A-25:135 — 392 Main Street West, Hamilton

The purpose of Minor Variance application A-25:135 is to permit the use of parking stackers to provide parking for a proposed six storey multiple dwelling, in accordance with Site Plan Control application DA-22-167. DA-22-167 received conditional approval on December 8, 2023.

**HEARING DATE: August 14, 2025**

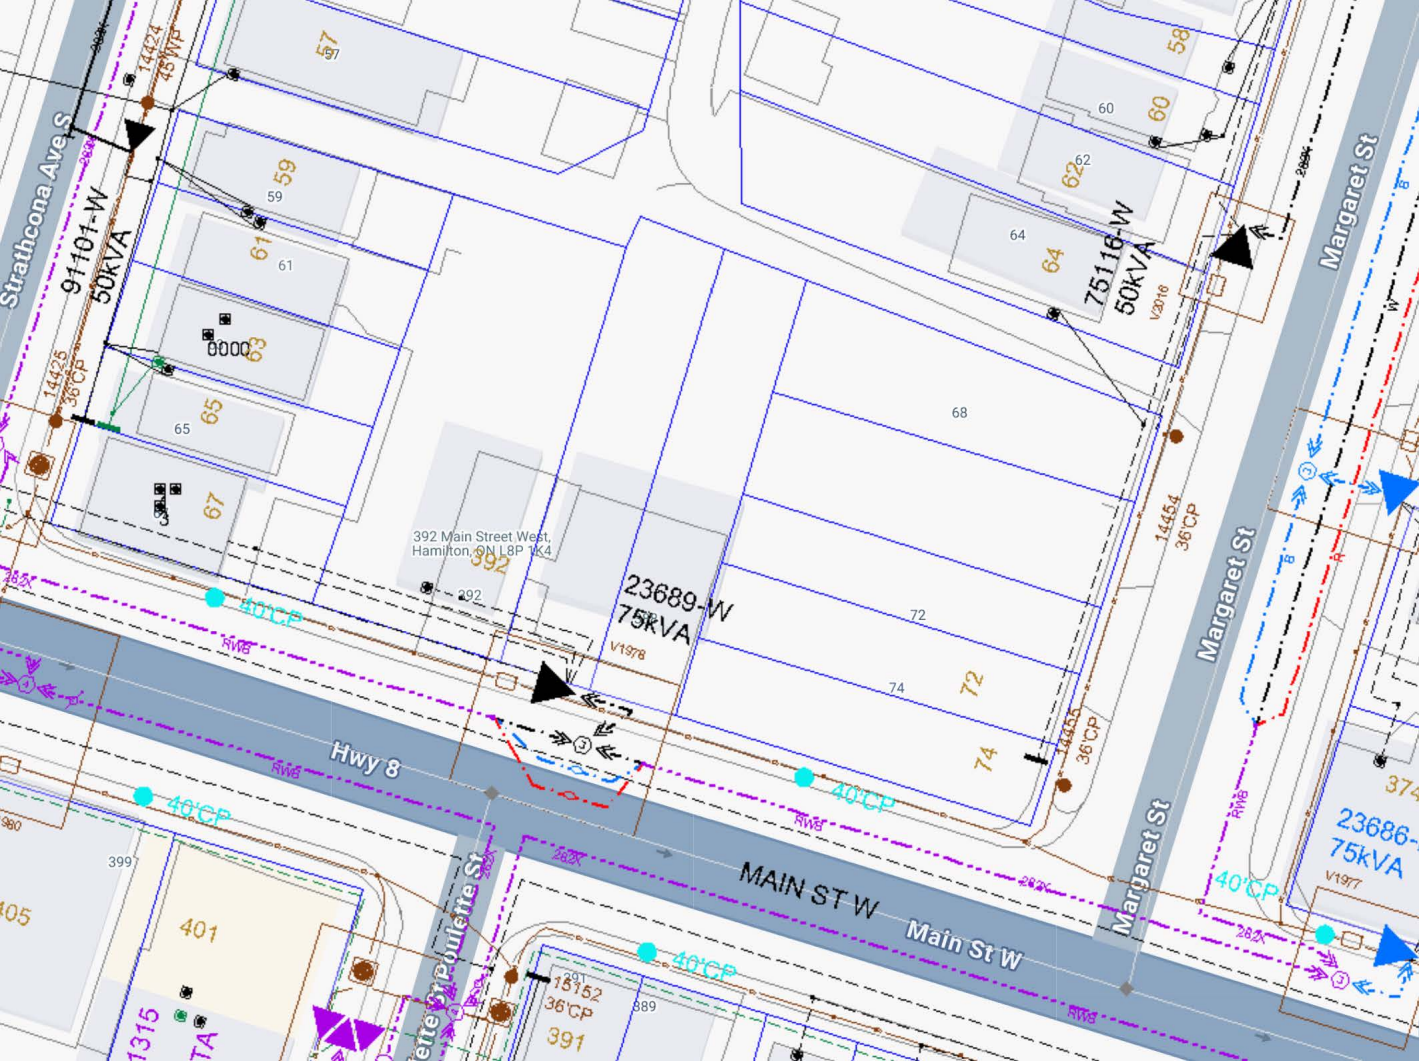
- Minimum 4m horizontal clearance from existing O/H line(s) must be maintained at all times as per Alectra Utilities Standard 3-105. Please consult with Alectra Utilities if further clarification is required.

- UNDER NO CIRCUMSTANCES SHALL A CONDUCTOR BE PERMITTED TO PENETRATE THE ENVELOPE SHOWN BY THE DOTTED LINE.

SYSTEM VOLTAGE	MINIMUM HORIZONTAL CLEARANCE DIMENSION "Y"	MINIMUM VERTICAL CLEARANCE DIMENSION "X"
0 - 750 V*	2.0 m (SEE NOTE 1)	4.5 m (SEE NOTE 3)
OVER 750 - 50000 V	4.0 m (SEE NOTE 2)	7.0 m (SEE NOTE 4)

- THIS CLEARANCE IS MADE UP OF A 1.0 m MINIMUM APPROACH CLEARANCE PLUS A 1.0 m ALLOWANCE FOR CONDUCTOR SWING. WHERE CONDUCTOR PASS IN FRONT OF A WINDOW OR OTHER OPENING, THIS 2.0 m CLEARANCE SHOULD BE INCREASED TO 2.5 m. WHERE BUILDINGS EXCEED 3 STOREYS OR 15.0 m IN HEIGHT, THE 2.0 m CLEARANCE SHOULD BE INCREASED TO 3.0 m TO ALLOW FOR RAISING OF LADDERS BY THE LOCAL FIRE DEPARTMENT.

- THIS CLEARANCE IS MADE UP OF A 3.0 m MINIMUM APPROACH CLEARANCE PLUS A 1.0 m ALLOWANCE FOR CONDUCTOR SWING.
- THIS DIMENSION PROVIDES 1.0 m MINIMUM APPROACH CLEARANCE FROM A 2.0 m TALL WORKMAN, PLUS A 1.5 m ALLOWANCE FOR CONDUCTOR SAG. (BASED ON AVERAGE SPAN OF 40 m)

- THIS DIMENSION PROVIDES 3.0 m MINIMUM APPROACH CLEARANCE FROM A 2.0 m TALL WORKMAN, PLUS A 2.0 m ALLOWANCE FOR CONDUCTOR SAG. (BASED ON AVERAGE SPAN OF 40 m).

- THE ABOVE CLEARANCES ARE MINIMUM VALUES. EFFORTS SHOULD BE MADE TO INCREASE THESE CLEARANCES ABOVE THOSE SHOWN, WHERE POSSIBLE. TO KEEP WORKMEN AND THEIR EQUIPMENT ON THE BUILDING ETC., AT THE MINIMUM CLEARANCE SHOWN, DIMENSION "X" AND "Y" ARE TO BE INCREASED BY THE REQUIRED WORKING DISTANCE.
